STAFF RECOMMENDATION
4205 Elkins Avenue
February 19, 2020

Application: New Construction—Addition (Revision to a Previously Approved Plan)
District: Park and Elkins Neighborhood Conservation Zoning Overlay
Council District: 24
Base Zoning: RS7.5
Map and Parcel Number: 091160L00100CO and 091160L00200CO
Applicant: Brad Bars
Project Lead: Melissa Sajid, melissa.sajid@nashville.gov

<p>Description of Project: Application is to revise a previously approved plan to construct a rear addition. As proposed the rear addition will be taller than the previous approval but no taller than the historic house. No changes to the historic house are proposed.</p> <p>Recommendation Summary: Staff recommends approval with the condition that staff approve the doors prior to purchase and installation.</p> <p>With this condition, staff finds that the project meets Section II.B of the <i>Park & Elkins Neighborhood Conservation District: Handbook and Design Guidelines</i>.</p>	<p>Attachments A: Photographs B: Site Plan C: Elevations</p>
---	--

SITE PLAN

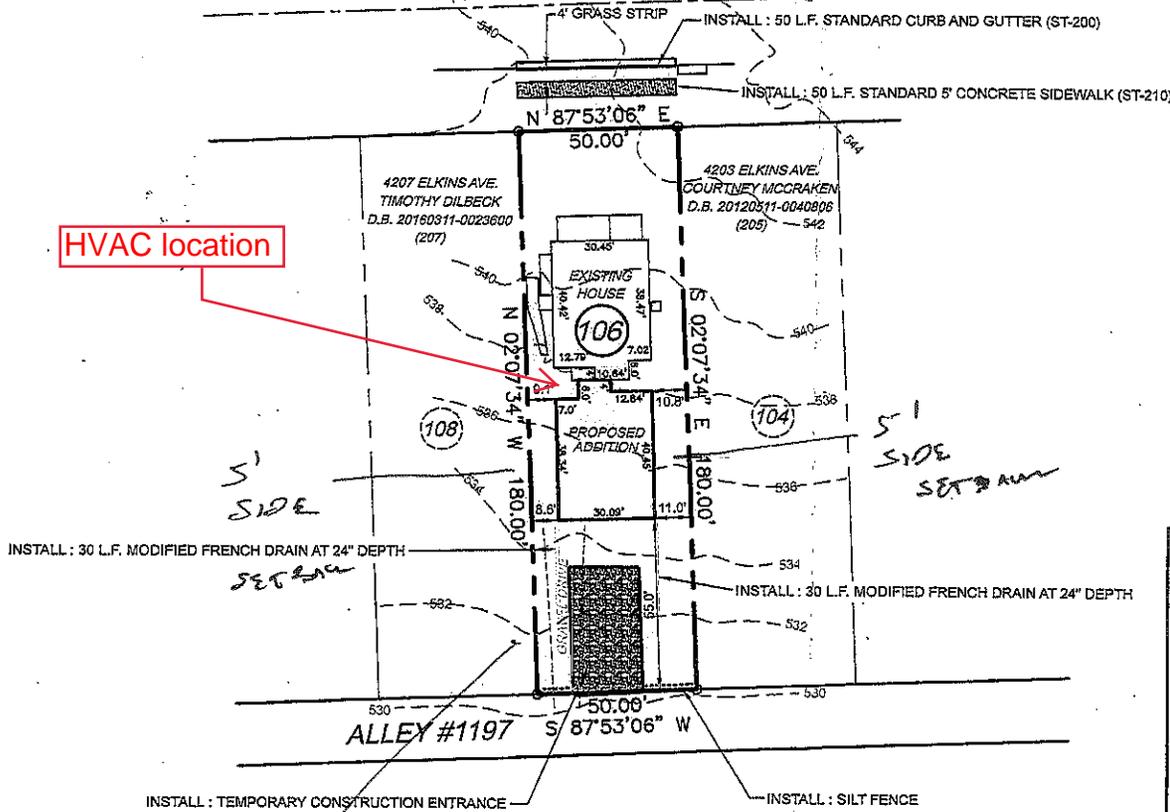
HVAC location

RIGHT SIDE ELEVATION

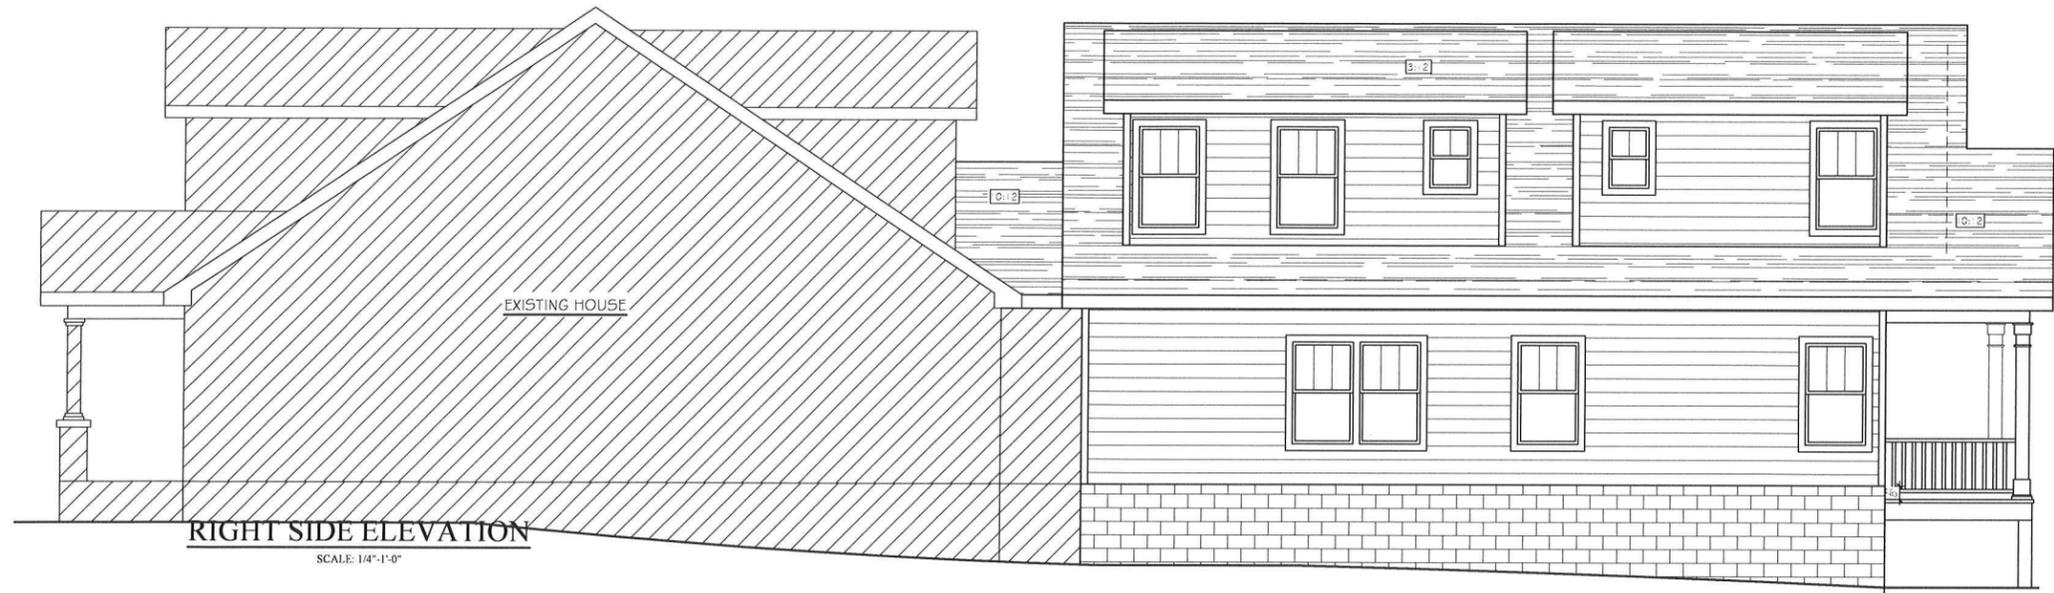
Height & Scale: The addition is situated at the rear of the historic house. As proposed, the addition is neither taller nor wider than the historic house and does not more than double the footprint. As proposed, the addition will match the height of the historic house and adds one thousand, two hundred, sixty-two square feet (1,262 sq. ft.) to the historic house, which currently has an approximate footprint of one thousand, three hundred, ninety-five square feet (1,395 sq. ft.).

Under the previous approval, the addition was to be situated two feet, six inches (2'-6") lower than the ridge of the house mostly due to the finished floor of the addition stepping down two feet (2') below that of the historic house. The addition, however, was constructed with a finished floor height that matched the existing house. Since the addition is no taller or wider than the historic house and does not more than double the footprint, staff finds that the addition's height and scale meet the design guidelines.

Design, Location & Removability: The location of the addition at the rear of the existing building is in accordance with the design guidelines and sets in two feet (2') from the left rear corner and approximately thirteen feet (13') from the right rear corner of the historic house. The addition goes back a minimum of four feet (4') on both sides before widening to be flush with the side walls of the historic house. All dormers on the addition set in two feet (2') from the wall below per the design guidelines. While the eaves on the dormers will be taller than the previous approval, staff finds that they can be appropriate since the dormers are set in as required by the design guidelines. In addition, the primary eaves on the addition will match those of the historic house.

Recommendation: Staff recommends approval with the condition that staff approve the doors prior to purchase and installation.
